## Modelling the sequential earthquake-tsunami response of coastal urban transport infrastructure

### Anonymous Referee #1, 21 Feb 2022

#### Anonymous Referee #2, 08 Mar 2022

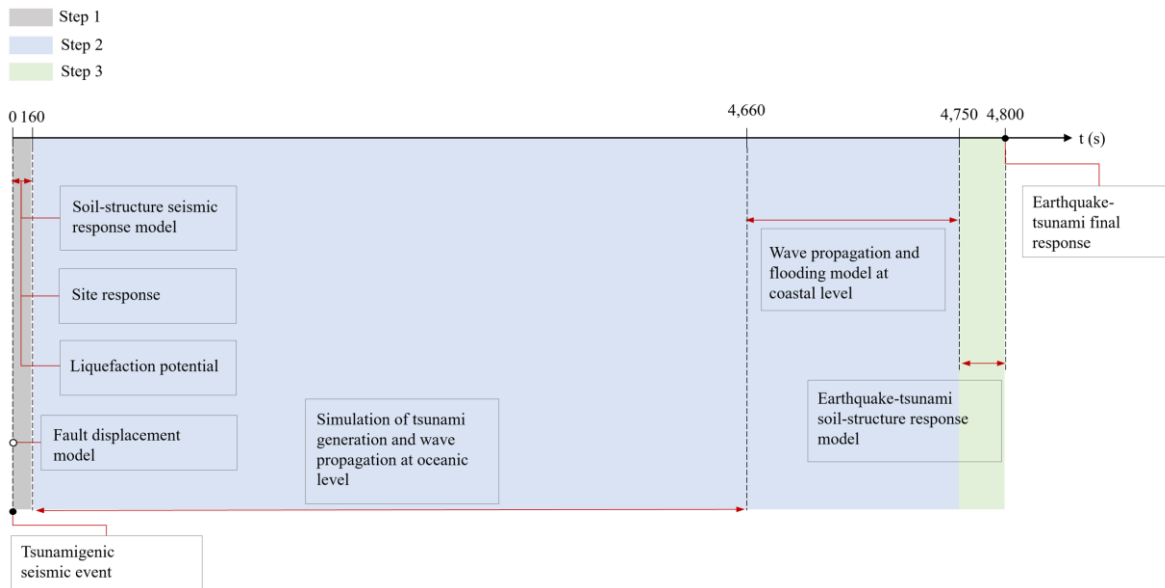
**6.- Line 309: One hour of simulation is not sufficient. The authors should check the recommendations in ASCE 7-16.**

AC: The authors consider that a practical estimation of the combined effect can be obtained from a shorter simulation time for the specific event analysed. A one-hour simulation period was found for the case study analysed according to records of the duration of the event regarding the wave arriving times (García et al. 1997; Borrero et al. 1997). However, for other cases, longer simulation times could be considered, such as those recommended by ASCE (Robertson, 2017). The authors acknowledge that the grid resolution of the propagation model is a possible research topic for the future. However, a higher resolution was not possible at the time the model was developed. The improvement in the grid spacing would help to reduce uncertainties in the expected flood elevations.

“Based on the calculated deformations and the characteristics of the earthquake, a tsunami-wave propagation model was run for a simulation period of 1 hour, beginning 15 minutes after the start of the earthquake. Figure 23 shows the simulation results for 1 min. A one-hour simulation period was found for the case study analysed according to records of the duration of the event regarding the wave arriving times (García et al. 1997; Borrero et al. 1997). However, for other cases, longer simulation times could be considered, such as those recommended by ASCE (Robertson, 2017). The authors acknowledge that the grid resolution of the propagation model is a possible research topic for the future. However, a higher resolution was not possible at the time the model was developed. The improvement in the grid spacing would help to reduce uncertainties in the expected flood elevations.”
